Access Compliance Report

Public Rights-of-Way

(Curb Ramps)

Intersection ID: 53044	Main Street: MELODY_WOODS_CT	Cross Street: WILLOW_OAK_RD	Location: SE
ADA ID: 2BBECD80FABF	Ramp Type: Perp	Initial Pass/Fail: Pass	Overall Compliance: No
			Severity Score: 20.25

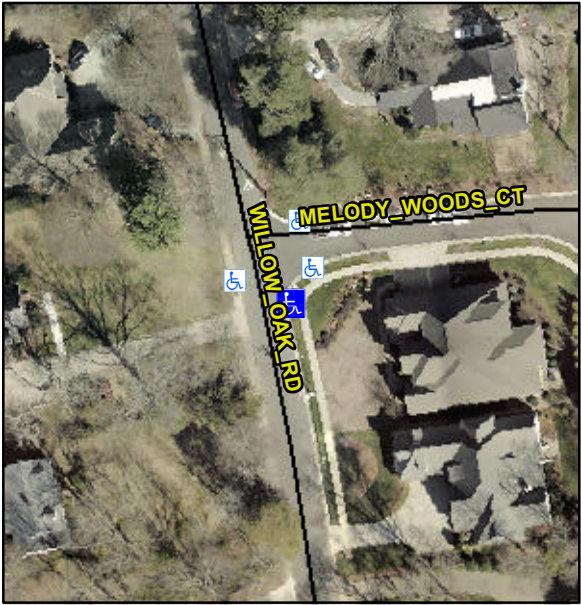
Codes/Mitigation Info/Possible Solution			Field Measurements/Component Compliance		
	Possible Solutions:		Compliance	Description	Data
	Remove & Replace Entire Ramp.		Yes	Ramp Length (in)	57.0
	Remove & Replace Gutter.		No	Ramp Width (in)	48.0
			N/A	Flare Type LT	Sloped
			N/A	Flare Slope LT (%)	1.6
			N/A	Flare Traversable LT?	Yes
			Yes	Landing Length (in)	48.5
			Yes	Landing Width (in)	48.0
			Yes	Landing Slope (%)	0.4
			Yes	Landing X Slope (%)	1.8
Surveyor Notes: N/A PROW/ADA: Not Found, R304.5.3, R305.2, R302.7.2, R304.5.4			N/A	Flare Type RT	N/A
			Yes	Flare Slope RT (%)	3.7
			N/A	Flare Traversable RT?	Yes
			Yes	DWS Provided?	Yes
			Yes	DWS Contrast?	Yes
			Yes	DWS Length (in)	24.0
			Yes	DWS Full Width?	Yes
			No	DWS Offset (in)	6.0
			No	Gutter Ponding?	No
			No	Gutter Lip Ht (in)	1.0
			N/A	Painted X Walk1?	No
				X Walk 1 Direction	To W
			N/A	X Walk 1 Width (in)	N/A
				X Walk 1 Slope (%)	6.5
				X Walk 1 X Slope (%)	0.2

N/A	Ramp inside XWalk1?	N/A
			N/A	Road Slope (%)	N/A
			N/A	Road X Slope (%)	N/A
			Yes	Any Obstructions?	No
				Obstruction Type	
Total Cost: \$ 2600.00			N/A	Storm Grate/Utility Hazard?	No
				Storm Grate/Utility Type	
			N/A		N/A
			Yes	Surface Condition? (G/P)	Good
